# UNITED STATES PATENT AND TRADEMARK OFFICE

APPLICATION NO.	FILING DATE	FIRST NAMED INVENTOR	ATTORNEY DOCKET NO.	CONFIRMATION NO.
10/688,663	10/16/2003	Norman Shendon	770C6-099006	1195
7590	06/03/2004			EXAMINER NGUYEN, GEORGE BINH MINH
PATENT COUNSEL APPLIED MATERIALS, INC. Legal Affairs Department P.O.Box 450A Santa Clara, CA 95052			ART UNIT 3723	PAPER NUMBER
DATE MAILED: 06/03/2004

<b>Office Action Summary</b>	<b>Application No.</b>	<b>Applicant(s)</b>	
	10/688,663	SHENDON ET AL.	
	<b>Examiner</b> George Nguyen	<b>Art Unit</b> 3723

## DETAILED ACTION

**Fig. 3A**

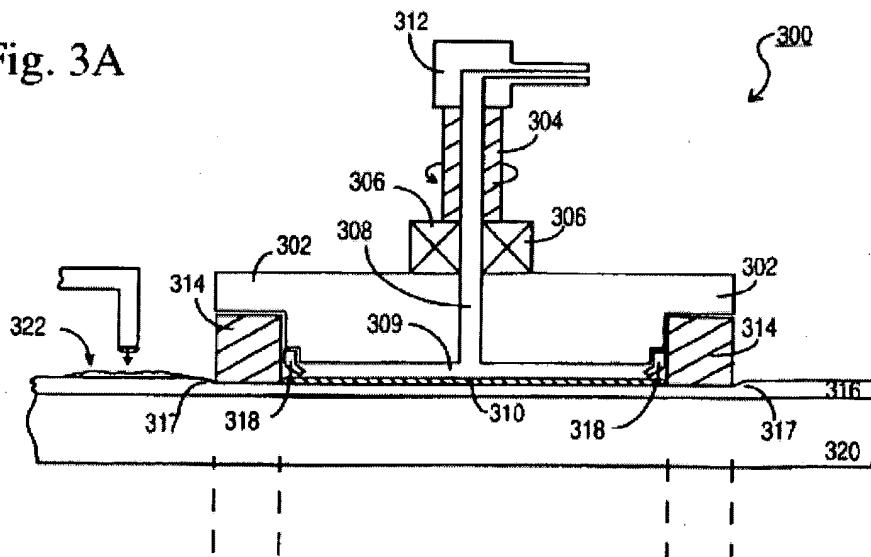
With reference to Fig. 3A, col. 4, line 25 to col. 5, line 25, Breivogel discloses the claimed invention.

Please note that the limitation of "housing" is broadly claimed that it could read on a housing supported the polishing pad. Thus, the backing member 302 is movable relative to such housing. Regarding to claims 5-6, the recess is the area created by the lip seal in combination with front surface of the backing area.

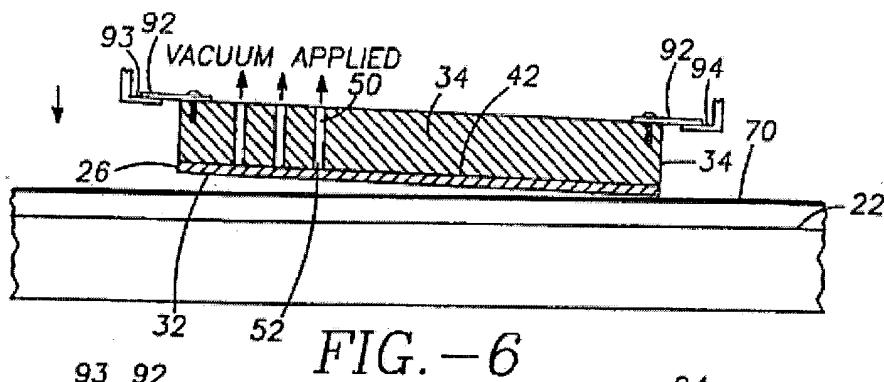
With reference to Figs. 3-5, col. 5, line 46 to col. 6, line 10, Shendon discloses a wafer polishing head that enables a wafer retainer to float during polishing and yet independently extends beyond the backing member 28 to control the movement of wafer during polishing or changing the wafer.

Please note that Shendon teaches a 1<sup>st</sup> chamber 23 between housing 12 and backing member 28. The 2<sup>nd</sup> chamber is the volume underneath membrane 29,

5. Thus, it would have been obvious to one having ordinary skill in the art at the time the invention was made to have modified the polishing apparatus of Breivogel with a retainer ring and 1<sup>st</sup> chamber and 2<sup>nd</sup> chamber as taught by Shendon to control the movement of the wafer.
